#5752

ON-SITE SEWERAGE FACILITY LICENSE
Issued by The Lower Colorado River Authority
An Authorized Agent of the Texas Natural Resources
Conservation Commission (TNRCC)

Re: Application No. 5752.10, Lake Buchanan, Indian Hills Store, Lot 491

PERCOLATION TEST REPORT

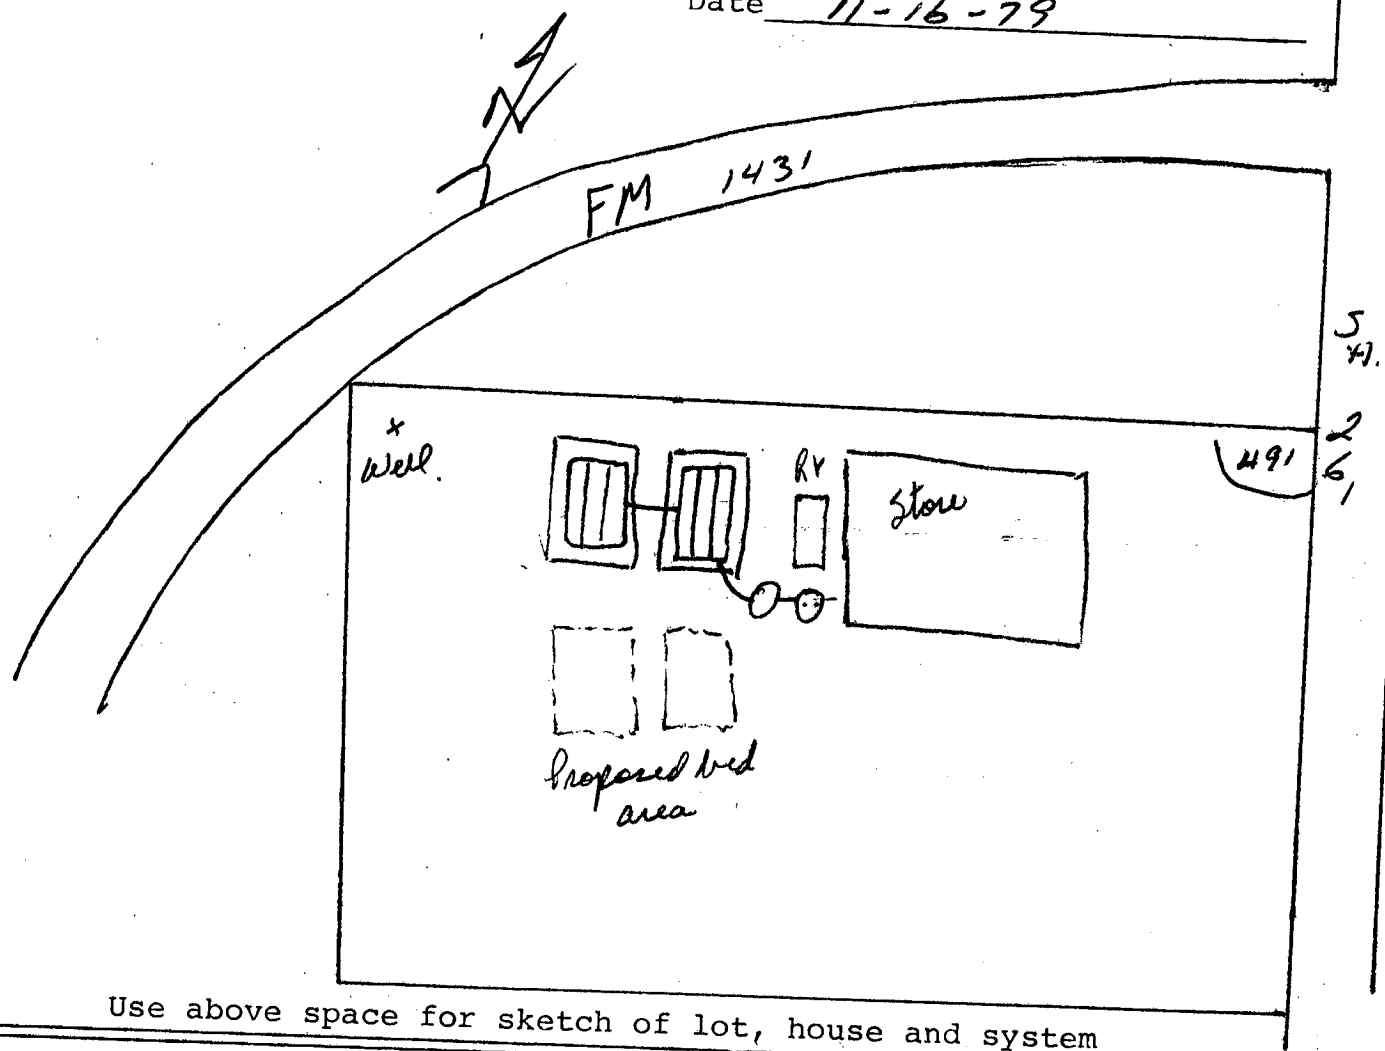
1. System is in WQ zone; 250+ feet to lake
2. Wells within ¹⁰⁰~~150~~ feet? yes on property. Locate on sketch
3. Soil conditions granite gravel and clay
4. Is proposed location approved? yes
5. Ground level? 8" to 1" / ft.
6. Special remarks and conditions Sandy loam backfill required.
Two absorption of equal area required

Tank Sizing:

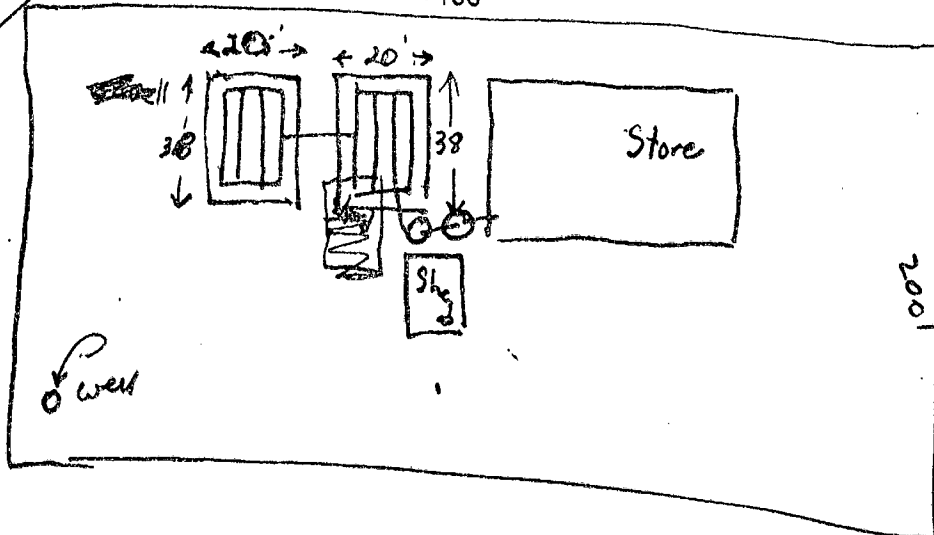
1. A minimum total capacity of a 350 gallon new septic tank to be used in series with the two-500 gallon existing tanks is required for this system.
2. A minimum of 1,010 square feet of absorption area in addition to the 1,520 square feet of existing field area will be required for this system.
3. Sandy loam backfill required.

675 gals./day $\times$ 2 days = 1350 gals.
 2 - 500 gal. tanks existing; therefore a
 minimum of 350 gals. of tank is
 required.

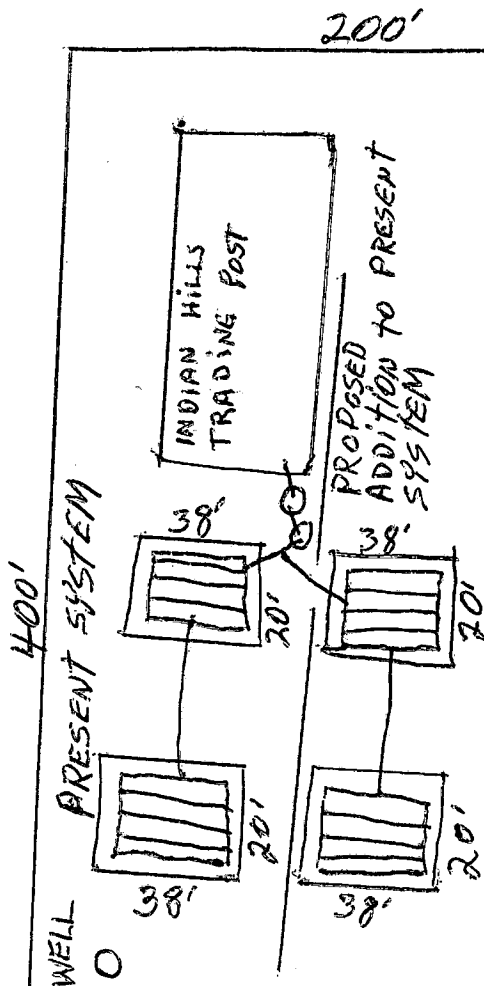
(To be filled in by LCRA, if different to size proposed) 1010 additional

field area.
1500 sq wicking.

1. INSTALL STOP VALVES SO WATER CAN BE ALTERNATED BETWEEN PRESENT AND PROPOSED PITS
2. ADSOR. BEDS 20' X 38' = 760' EA. TOTAL 1520'
3. ROCK DOW #1
4. SAND CLEAN LAKE

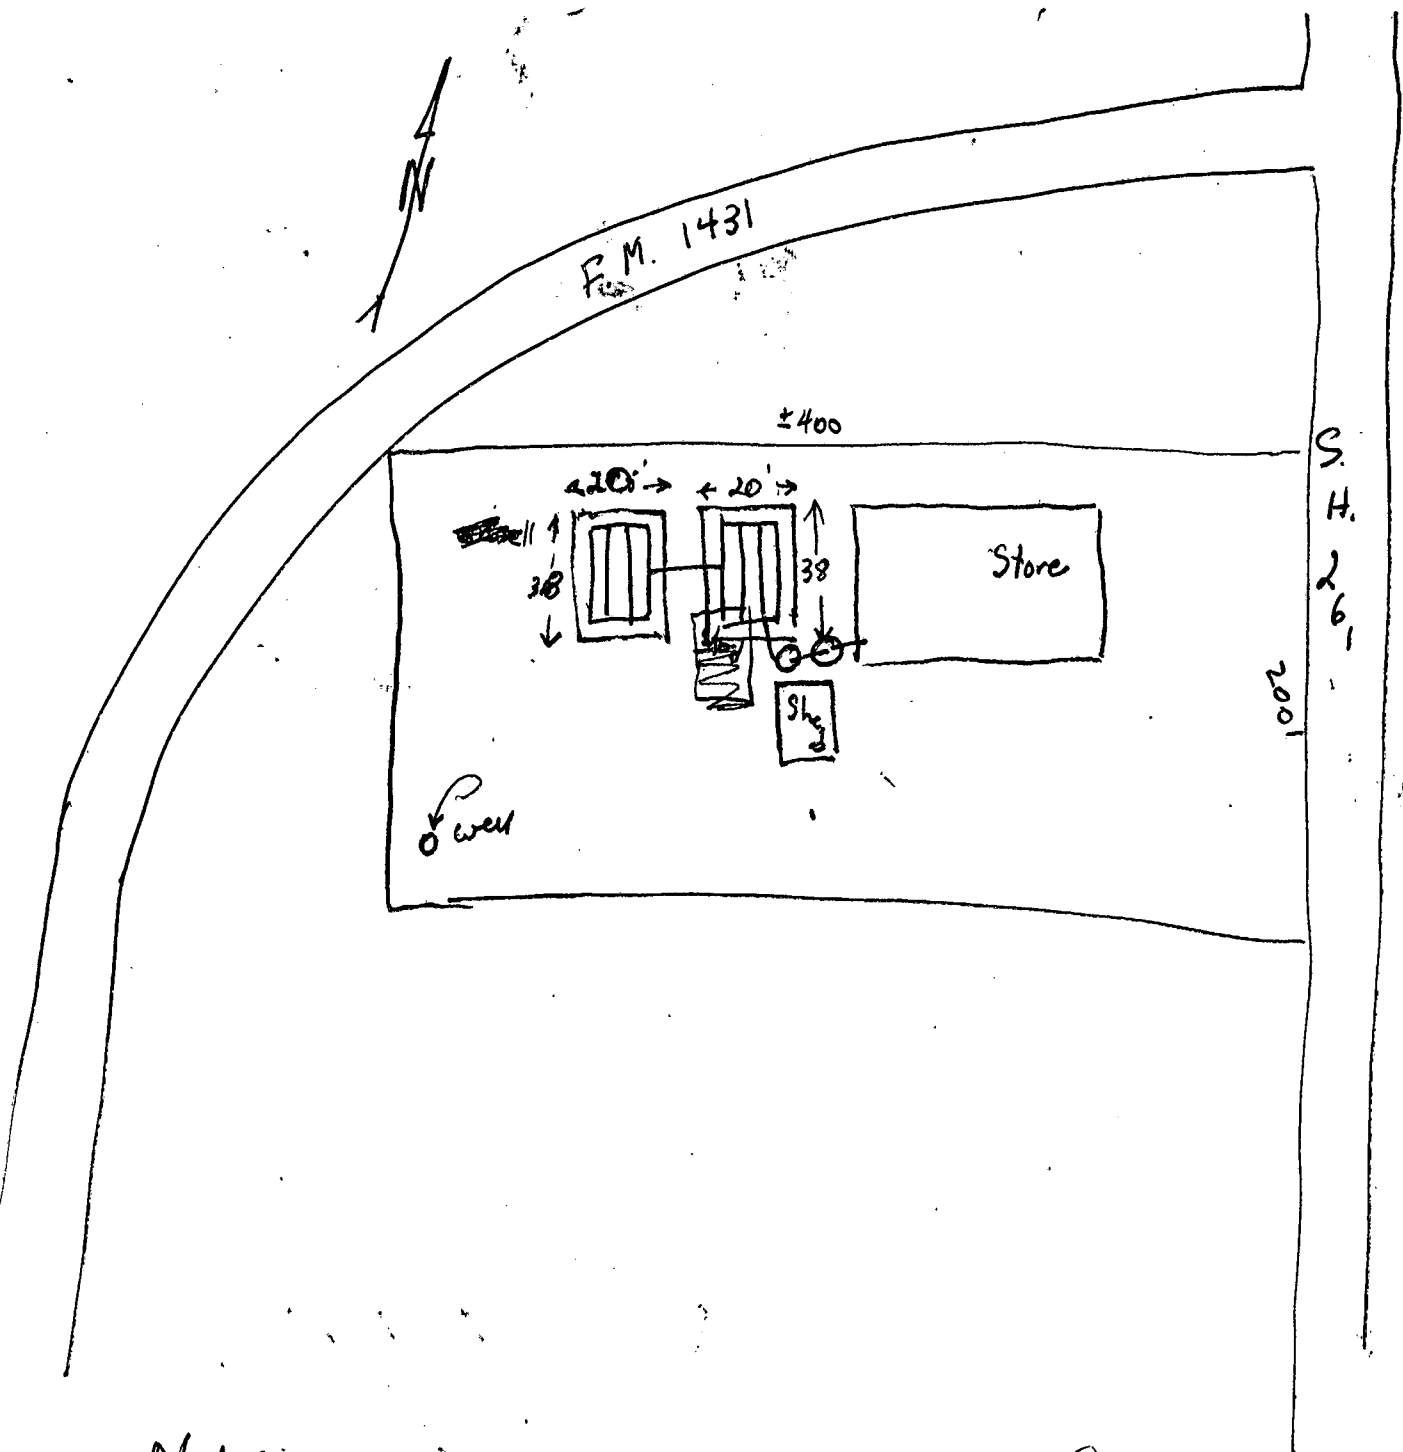
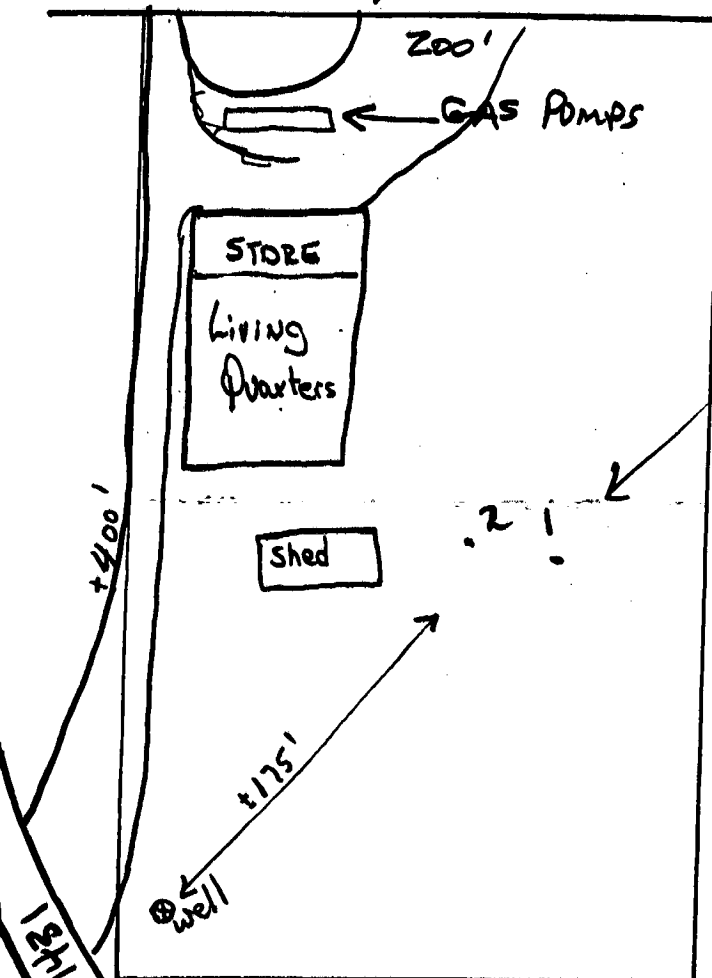
Septic Tanks
& Absorp. Beds were
re sited to locate
the system on same
lot as store

Sept inst per approved design
except as noted above & IAW D/H standards & LCRA Supp.
As-Built on Reverse
